**THE REGIONAL MUNICIPALITY OF YORK**

**Request for Tender No. T-19-349 Addendum #1**

**For:** Interior Renovation – 3<sup>rd</sup> Floor Block A, B, & D at the York Region Administrative Centre

ADDENDUM

SHEET NUMBER:

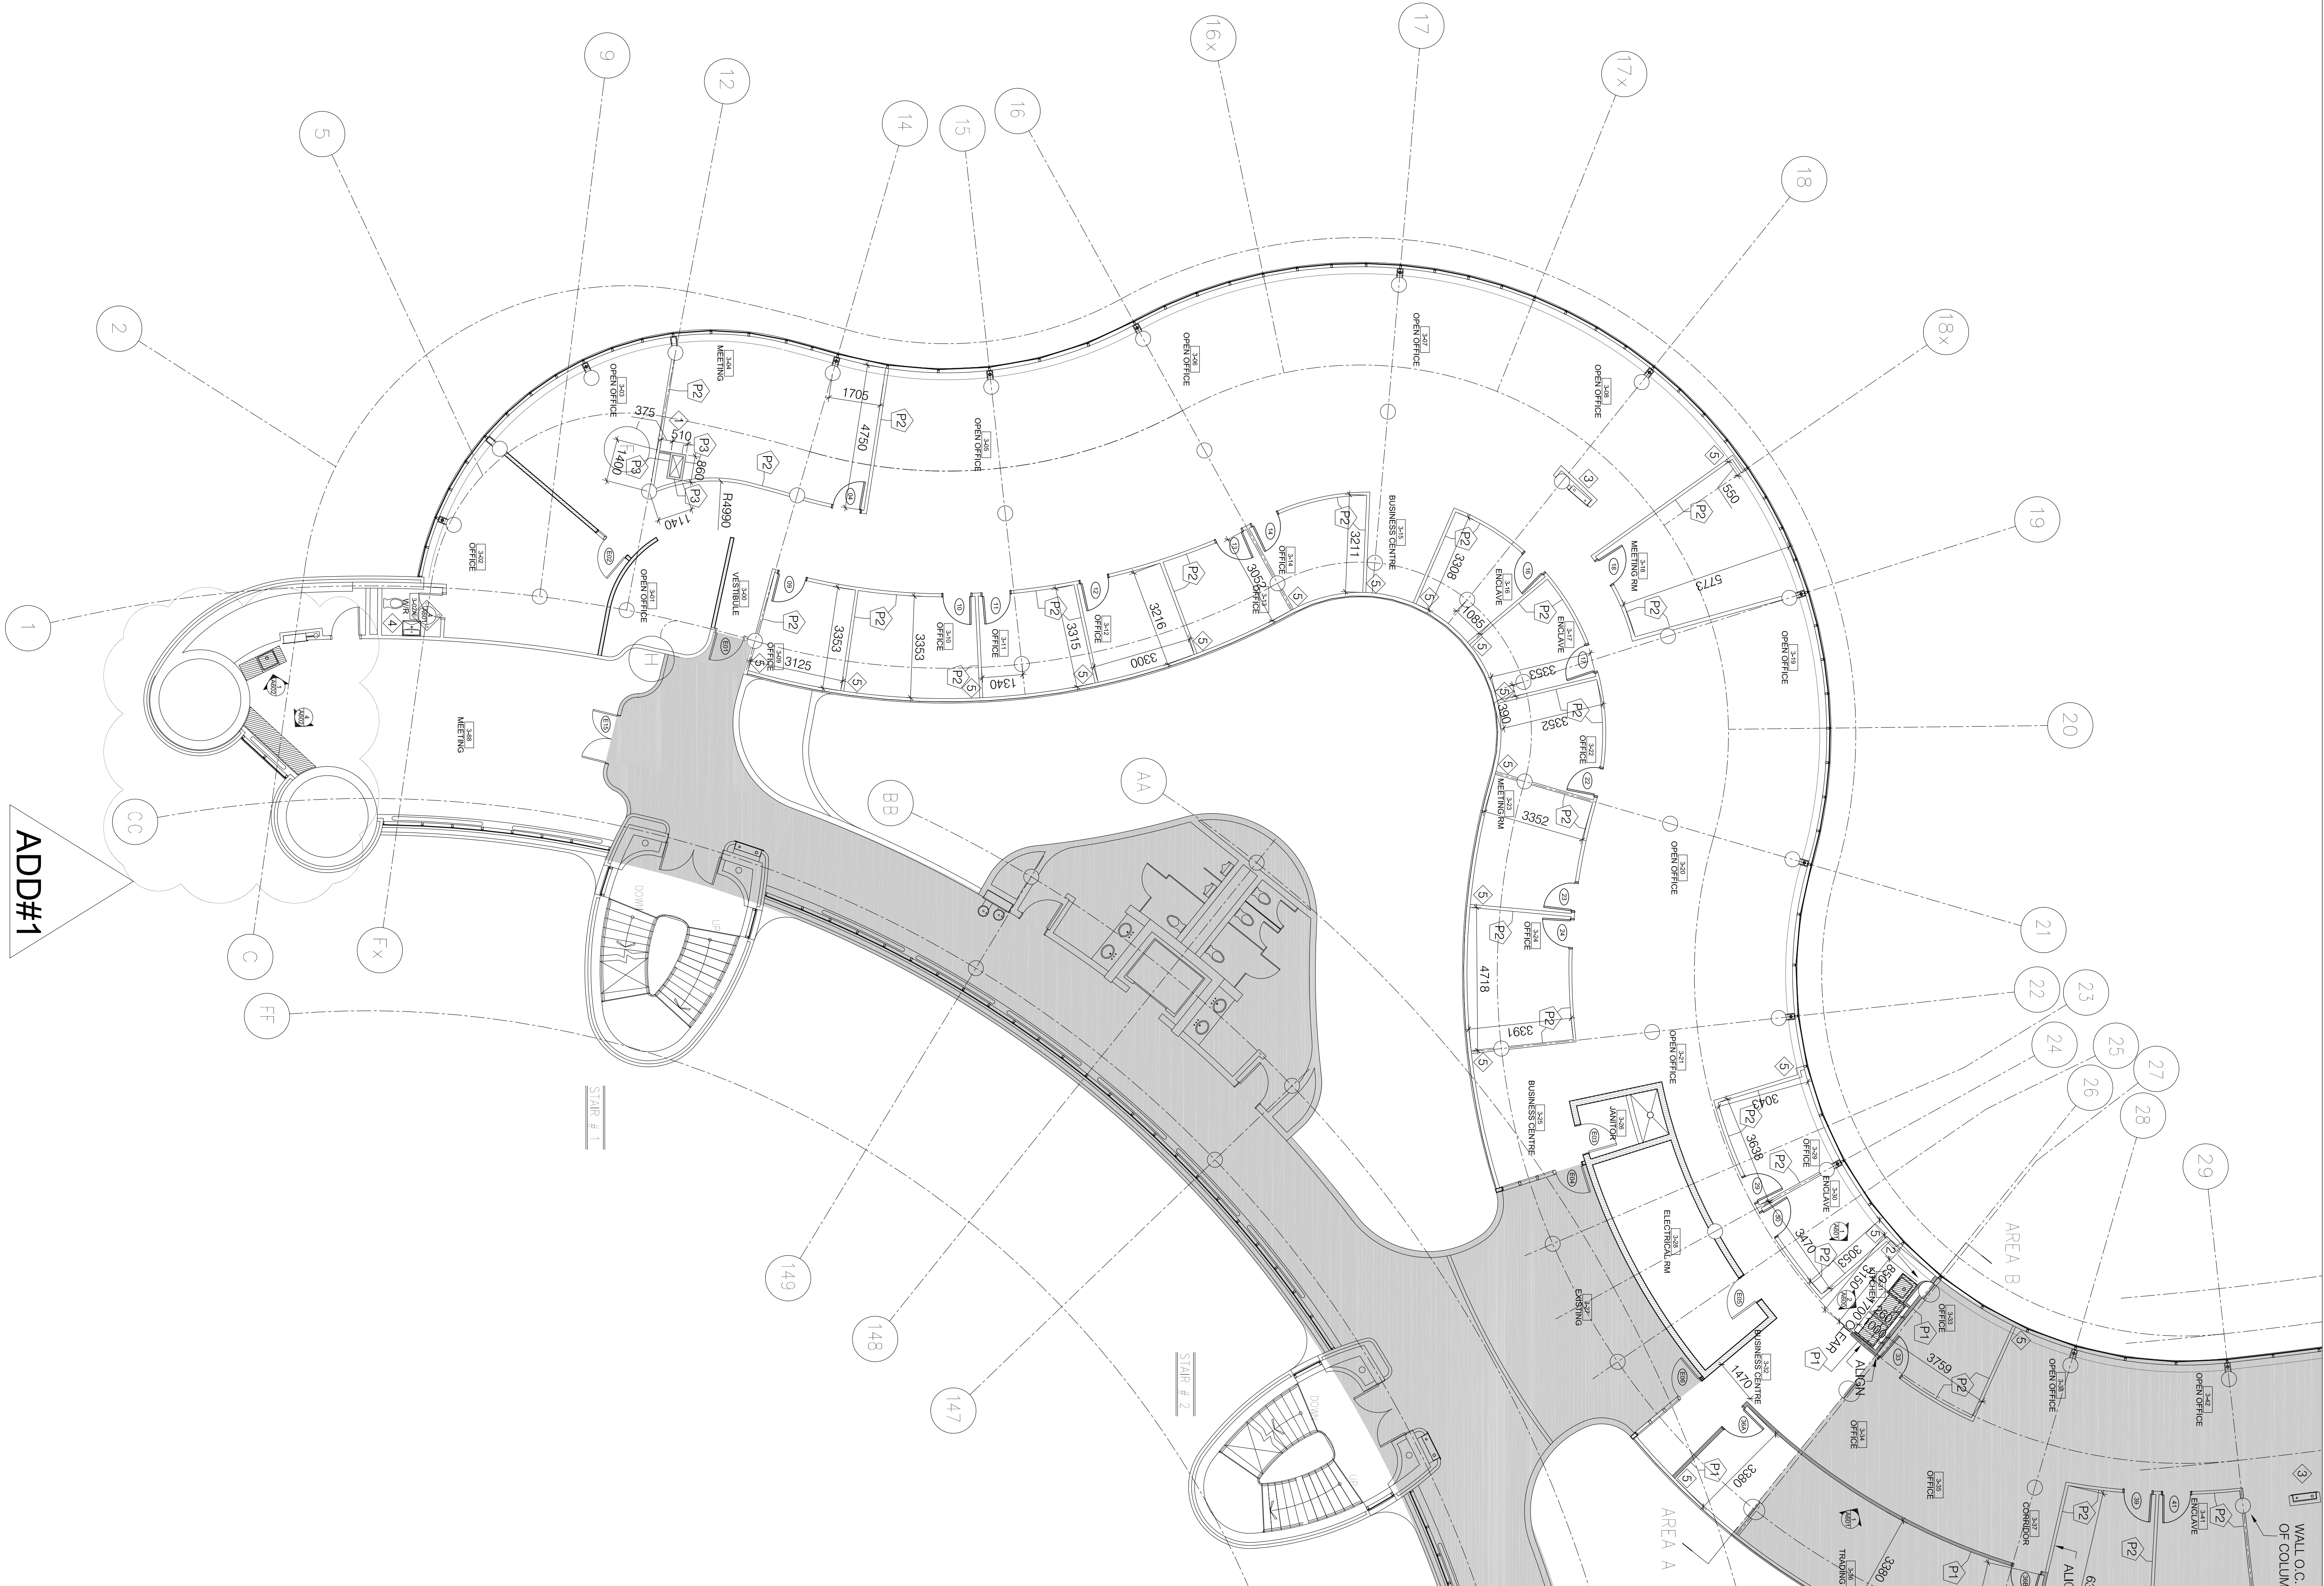
#### 1.1 Refer to E-3.6 – LEVEL 3 WASHROOMS – POWER AND SYSTEMS LAYOUT (included herein)

1.1.1 Revise location and revise connection for hand dryers to be direct connects in washrooms, as shown.

1.1.2 Revise circuiting of washroom fixtures, as shown.

1.1.3 Add note N-4, as shown.

.1 “PROVIDE TANDEM BREAKERS FOR CIRCUITS SHOWN AS A/B. (TYP.)”

SHEET NUMBER:  
A200

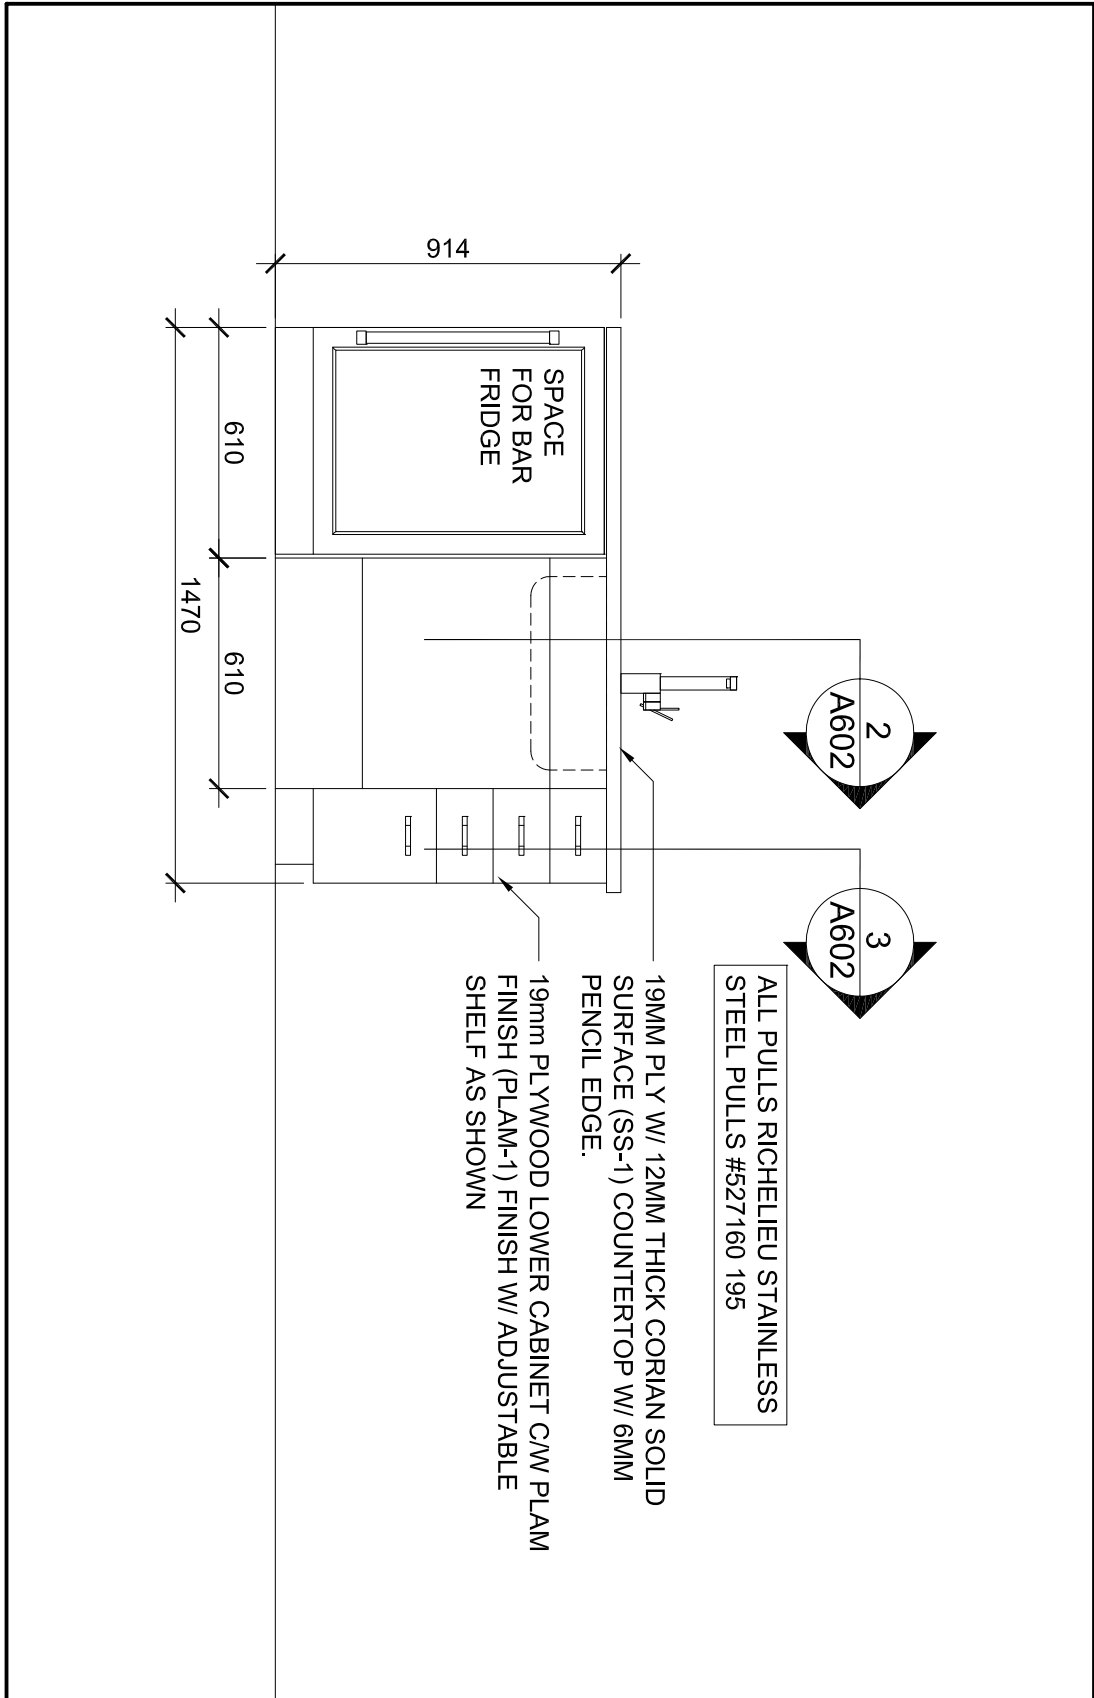
Q29. Any millwork detail for Meeting Room 3-88?

**A29. Yes, refer to attached revised drawing A200 and new detail Drawing A602.**
